Subject: NRC Request for Additional Information

Docket No. 50-184

In response to your letter of January 30, 2015, please find enclosed the NIST Center for Neutron Research (NCNR) answers to the RAI for the license amendment request to change two technical specifications for the station battery. Any questions regarding the NCNR response should be directed to Dr. Paul Brand, Acting Chief, Reactor Operations and Engineering. Dr. Brand may be reached at paul.brand@nist.gov or (301) 975-6257.

Response to RAI of January 30, 2015
NATIONAL INSTITUTE OF STANDARDS AND TECHNOLOGY
TEST REACTOR

ATTACHMENT 1
BEFORE Configuration of UPS (battery charger) and Station Battery

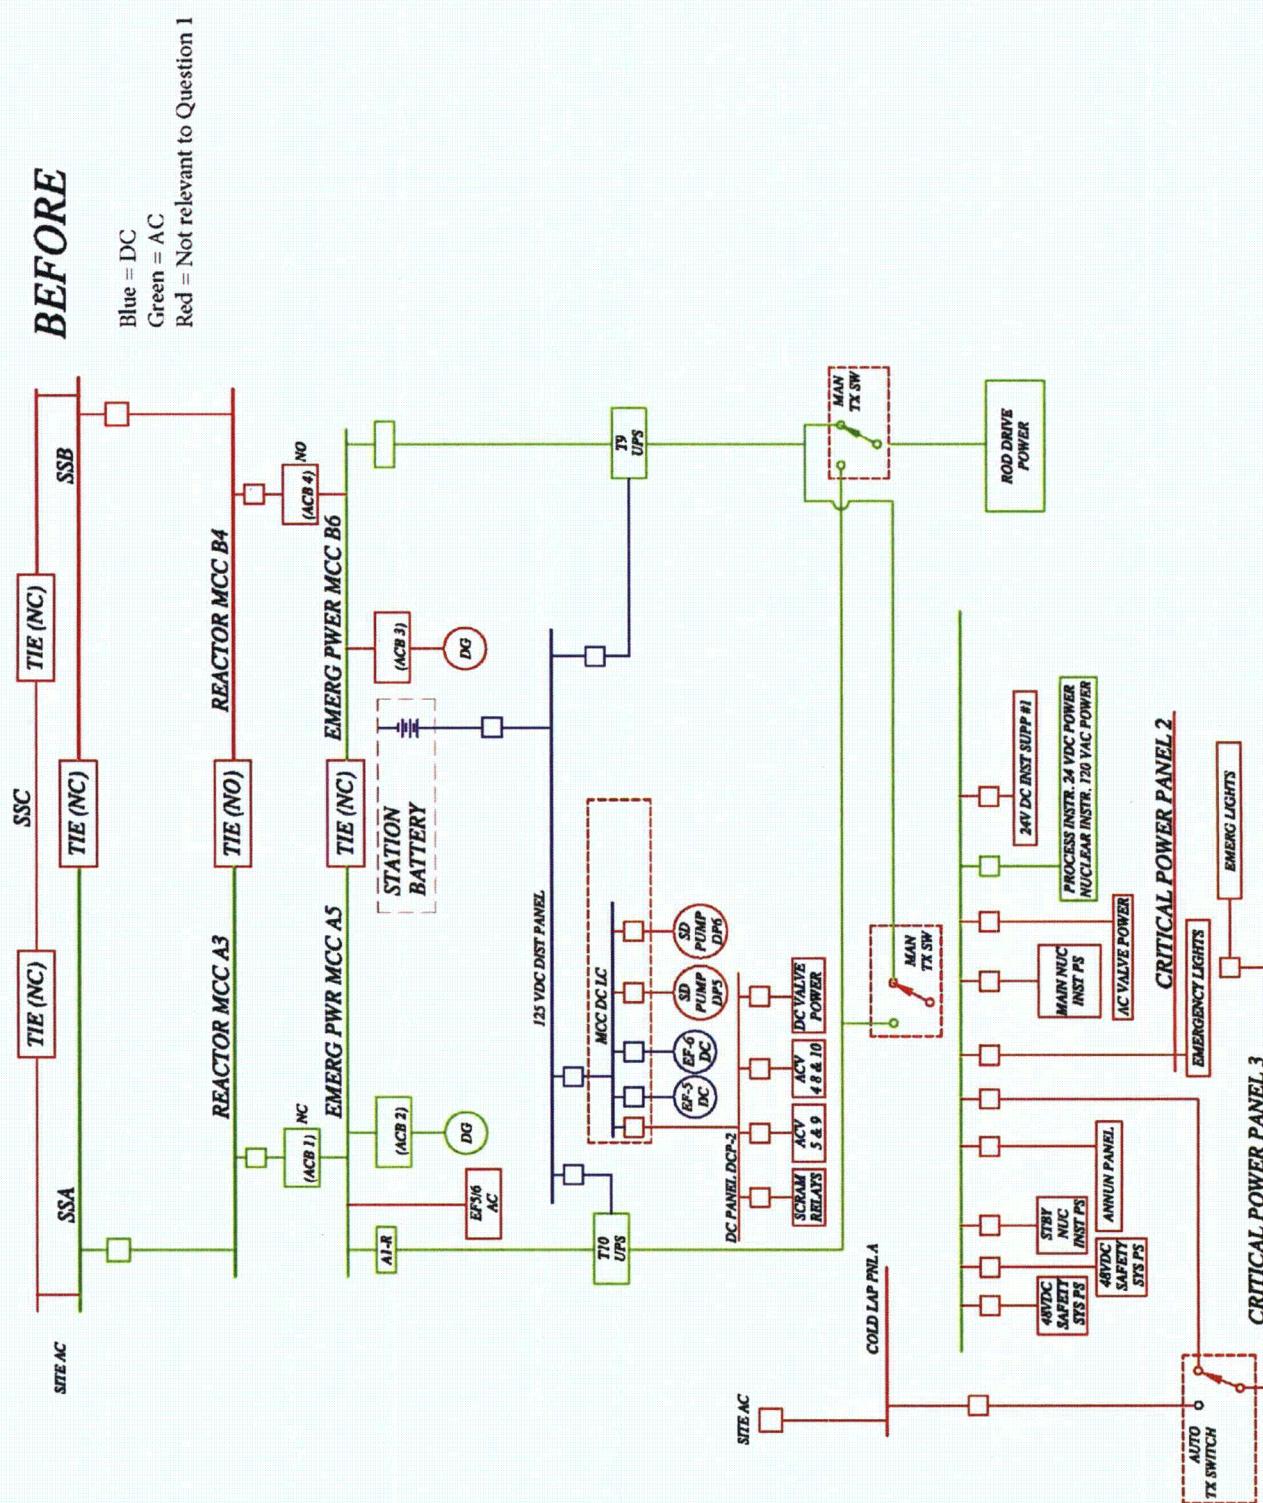
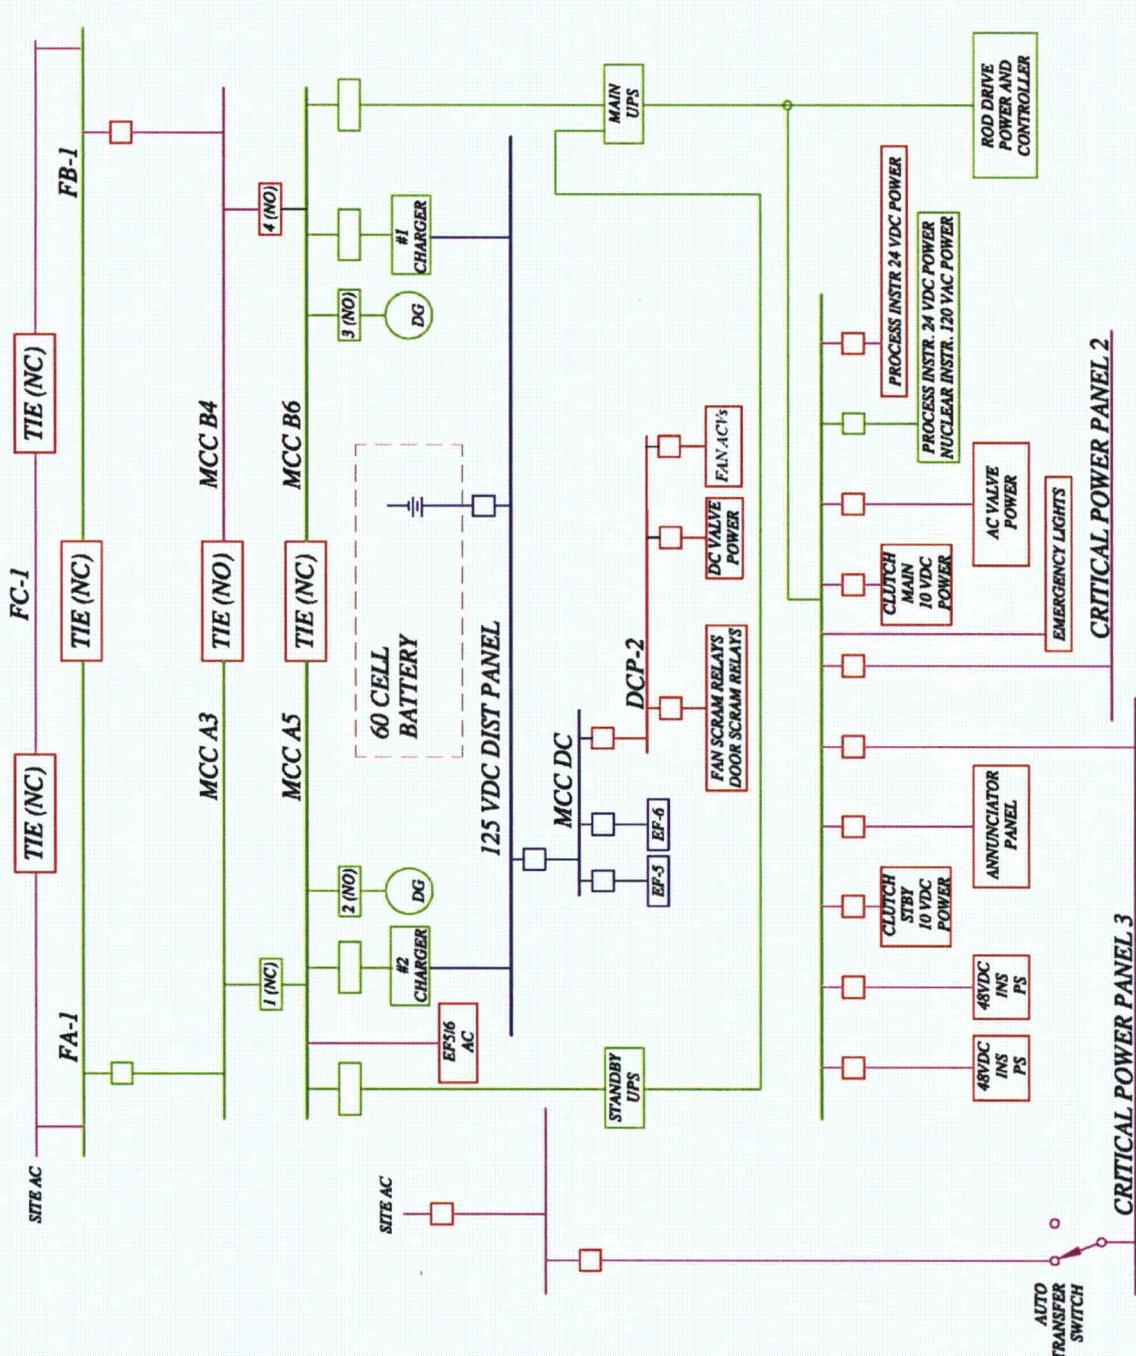
- a) Provide an overview of the systems that are affected by this LAR.
- b) Provide a one-line diagram that shows the current and the proposed configurations of the UPS system including the station battery, direct current (DC) Distribution Panel, and Critical Power Panel.

Answer to Questions 1a and 1b: Please see the attached drawings, Before Configuration and After Configuration. Electrical loads, motor control centers, switchboards, etc. were not affected by this change.

The two existing 20 kVA UPS, T9 and T10, were replaced with two 20 kVA UPS of a different design but of the same output capacity. The replacement UPS are designated as MAIN UPS and STANDBY UPS.

Battery power was changed from the existing 60-cell lead-antimony battery bank to the existing 60-cell lead-antimony battery bank + a 72 cell VRLA bank + a spare 72 cell VRLA battery bank. Previously, the Station Battery = 60-cell battery bank; now the Station Battery = 60-cell battery bank + one VRLA battery bank. No credit for battery power is taken for the spare VRLA battery bank.

The 60-cell battery charging capability of T9 UPS was replaced with a stand-alone battery charger and the 60-cell battery charging capability of the T10 UPS was also replaced with a stand-alone battery charger. In addition, the charging configuration for the 60-cell battery bank has been changed. T9 UPS and T10 UPS were not in service at the same time; T9 or T10 charged the 60-cell battery. The replacement chargers operate in parallel, both charging the battery, with one charger nominally the primary charger.

Annotated Excerpt from EATON 9390 UPS Installation and Operation Manual

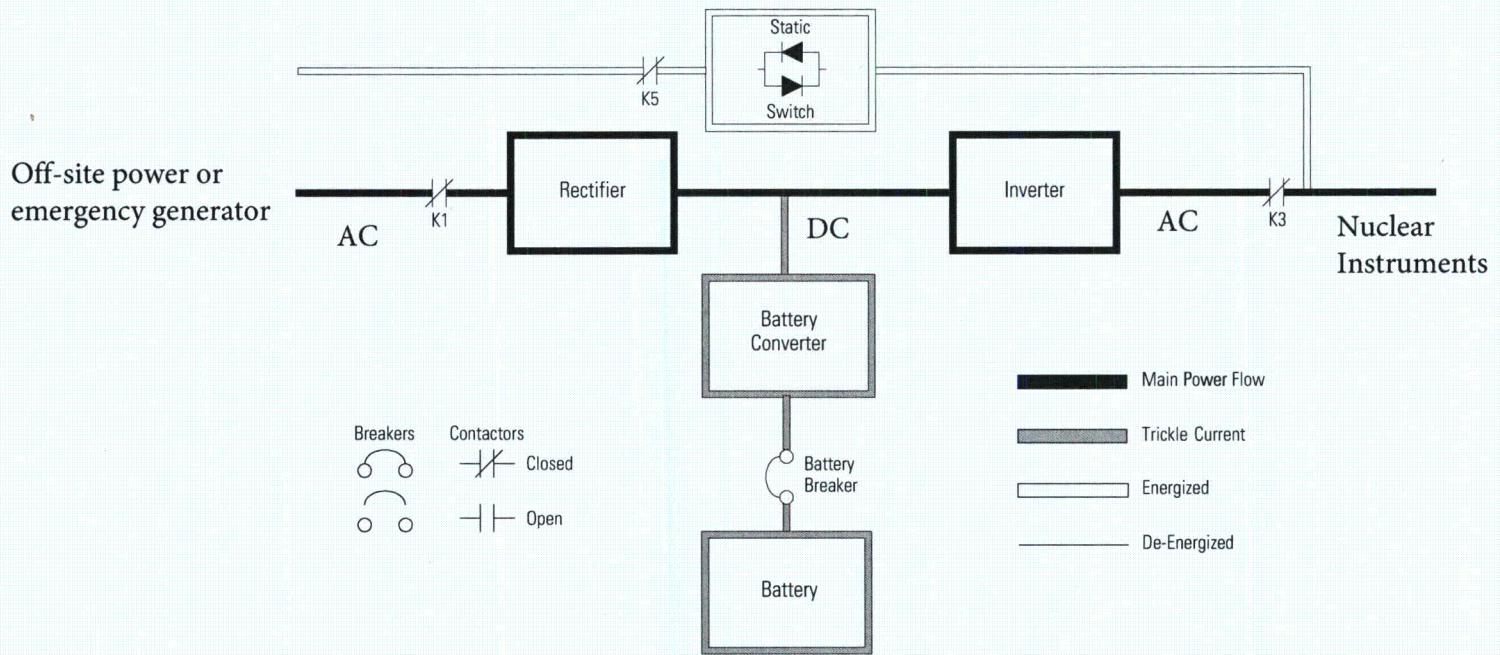
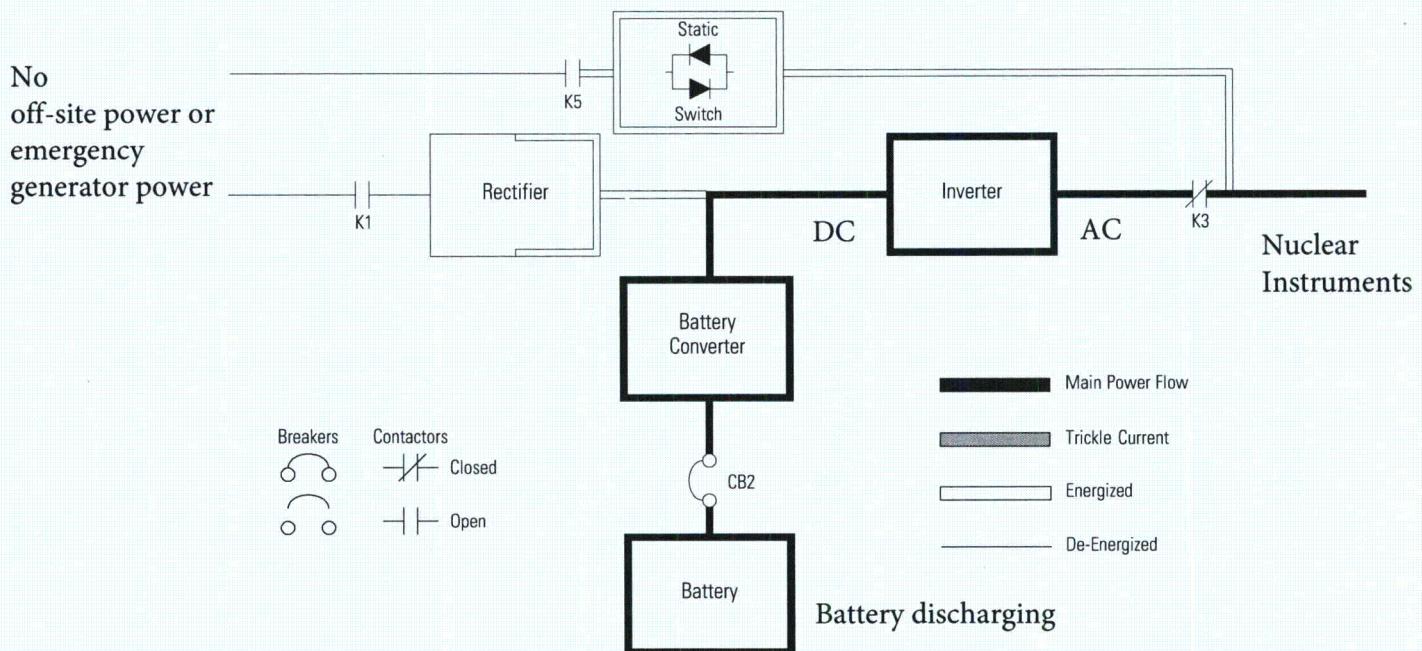
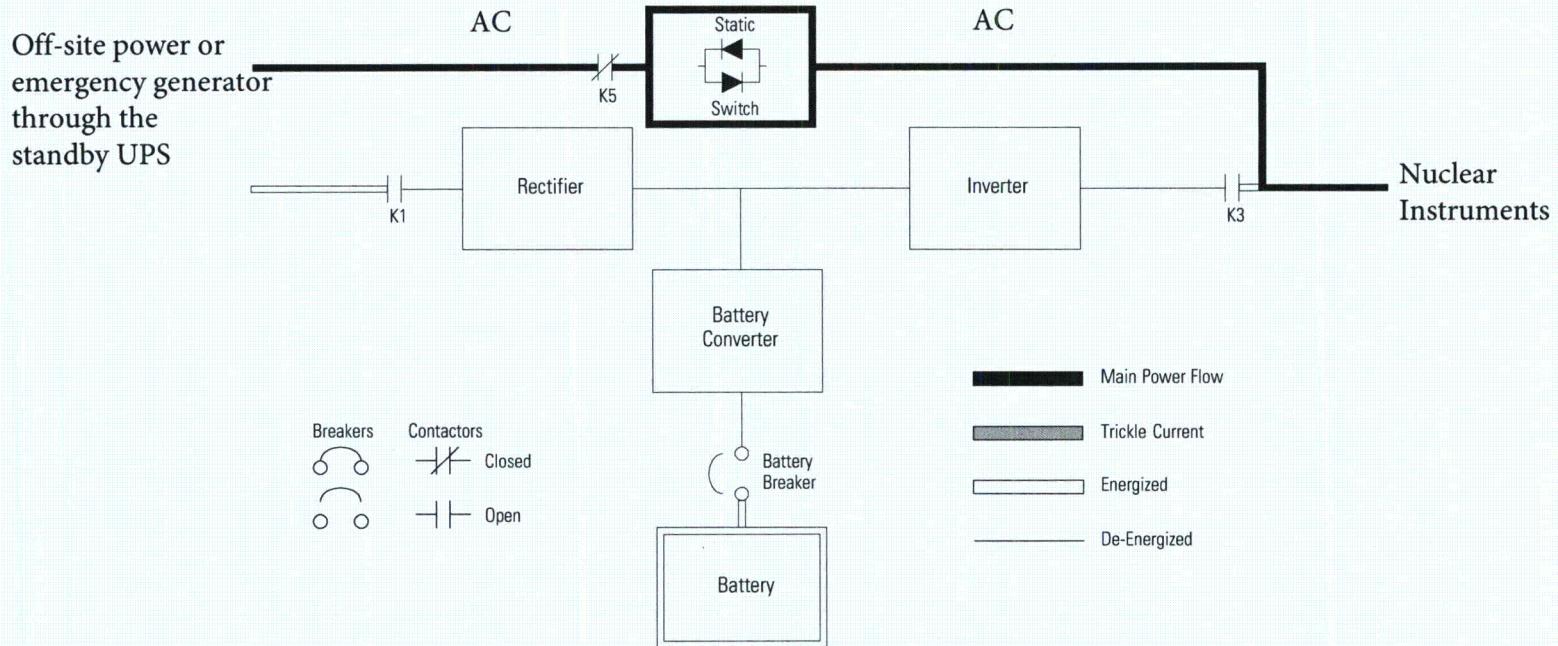
- a) Clarify if the battery charger and the VLRA battery are included in the UPS unit. Also, provide a simplified block diagram that shows how the UPS, the VLRA battery, and the battery charger are interconnected.

Answer to Question 2.a: The stand-alone battery chargers are not included in the UPS unit and those battery chargers have no interaction with the UPS. A VLRA battery bank is part of an UPS and is charged only through the UPS of which the bank is part. See the excerpts, including simplified block diagrams, from the UPS manual in Attachment 2.
